Elevation QC Report

Project: OR_CVO-NEWBERRY-DEL1_2010

Contractor: Watershed Sciences

Reviewer: Hannah Boggs

OR CVO-Newberry-Del1 2010: Example of Building Not Flattened

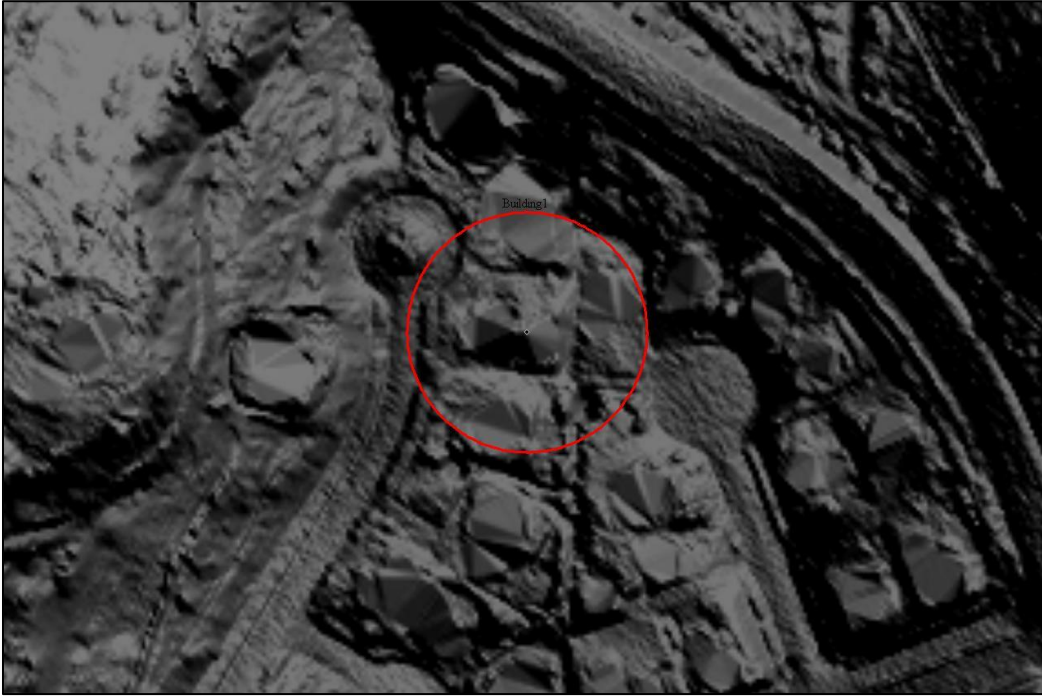
Bare earth surface is good. Through the majority of the project, there is not excessive "over-editing" of the bare earth points. All vegetation and bridges appear to be removed properly. Most building were removed properly, however, reviewer found some buildings not removed. Examples are provided below. The surface is free from very high points that are most likely noise, and quilting. Artifacts near edges are present, examples are provided below.

OR_CVO-Newberry-Del1 2010: Example of Double Line Stream Not Forced to Flow Downstream (2)

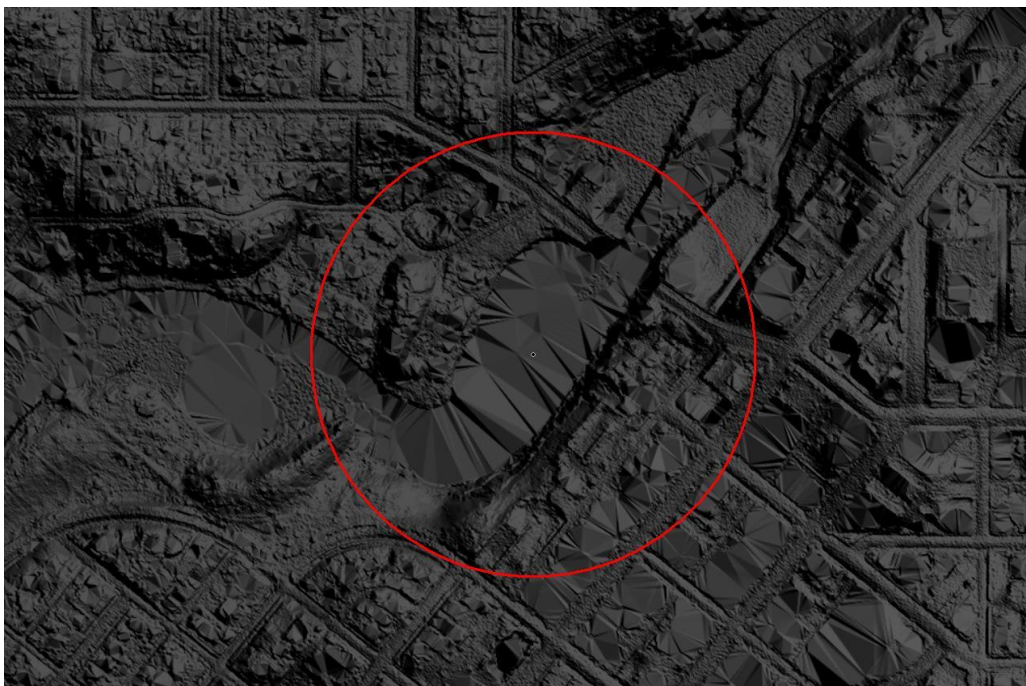
There was no requirement for treatment of waterbodies or double line streams. There are double line streams present that have not been forced to drain downhill. Reviewer created a shapefile documenting double line streams that have not been forced to drain downhill. Examples will be provided below.
